RE: RESPONSE TO REQUEST FOR ADDITIONAL INFORMATION – SSD-82548708

PROPERTY AT: 24, 26 AND 28 MIDDLE HARBOUR ROAD, LINDFIELD

Reference is made to **SSD-82548708**, which seeks development consent for the purposes of a residential flat building (RFB) with affordable housing and Build to House (BtH) housing at 24, 26 and 28 Middle Harbour Road, Lindfield (the Site).

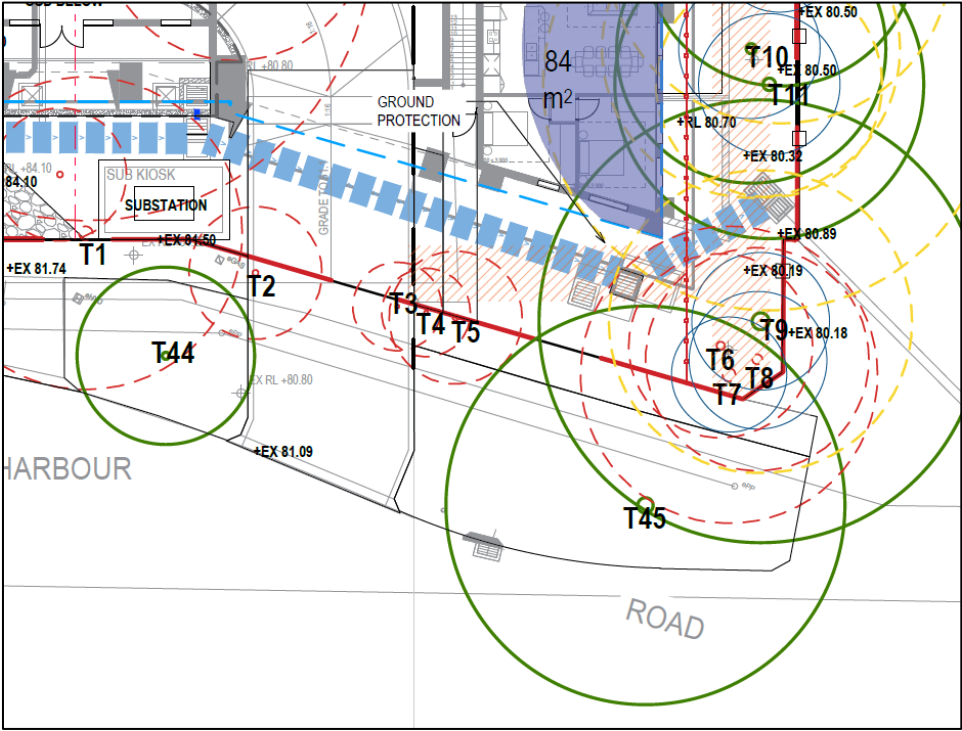
Item	Submission	Response
	d) <i>A footpath design is to be provided along the site's frontage and is to be designed in accordance with Council drawing 2003-004 Rev. 'B'. A footpath longitudinal section will also need to show the extent of cut/fill, existing services and existing street tree locations. The project arborist will need to endorse the civil plans. All redundant driveway crossing are to be shown to be removed.</i>	This is considered to be a technical matter that can be resolved at detailed design stage, with details secured prior to any CC in a condition of consent. Both the original and revised Arboricultural Impact Assessments (AIA) confirm that all six (6) street trees (despite some being in poor condition) are proposed to be retained and protected throughout all stages of the Proposal, including the demolition and construction phases. One (1) street tree (Tree 45) is located in proximity to the proposed crossover and driveway, illustrated in Figure 1 below. The AIA recommends specific techniques for the excavation and construction of the proposed crossover and driveway to enable the identification of any roots of the tree. If woody roots are identified, advice from the Project Arborist would be required. The recommendations of the AIA, including protection measures, are captured within the updated Mitigation Measures within the RtS Report.

TABLE 1 - RESPONSE TO DPHI COMMENTS		
Item	Submission	Response
		 Figure 1: Proposed Crossover Street Tree Locations (Source: Land Form, 2026) Furthermore, the AIA assessed three (3) of the street trees (Tree 42, Tree 43 and Tree 44) to be in poor form and vigour, with two (2) having less than 5% foliage and appear to be dying. If Council considers it appropriate, these trees can be replaced as part of the Proposal as a condition of consent.

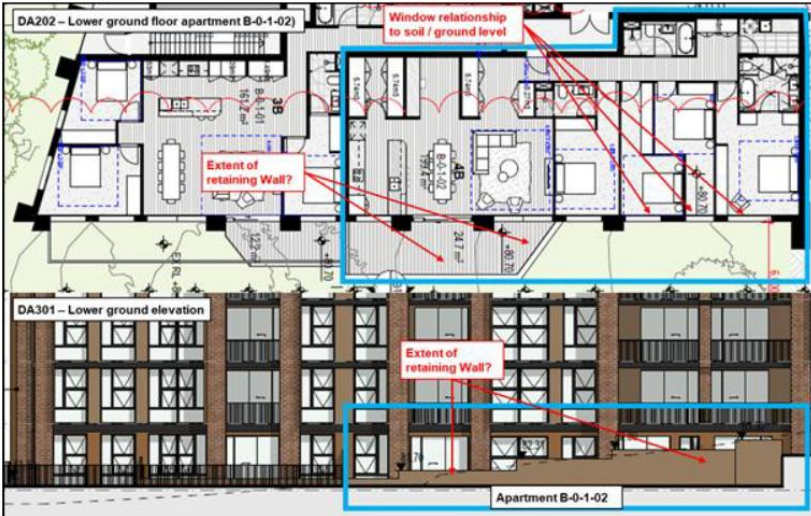
c) The retaining wall shown on elevation DA301 is inconsistent with the retaining wall shown on plan DA202 (see extract below). Accordingly, provide clarification and update any plans if required. Please note, if the retaining wall is as proposed in elevation, this would have significant additional impacts on trees proposed for retention.	The elevation has been amended (DA301 Rev 05) to be consistent with the proposed floor plans. Regarding impacts to retained trees, the revised AIA factors in the proposed retaining wall and confirms that the retained trees will not be adversely impacted and can be successfully retained.
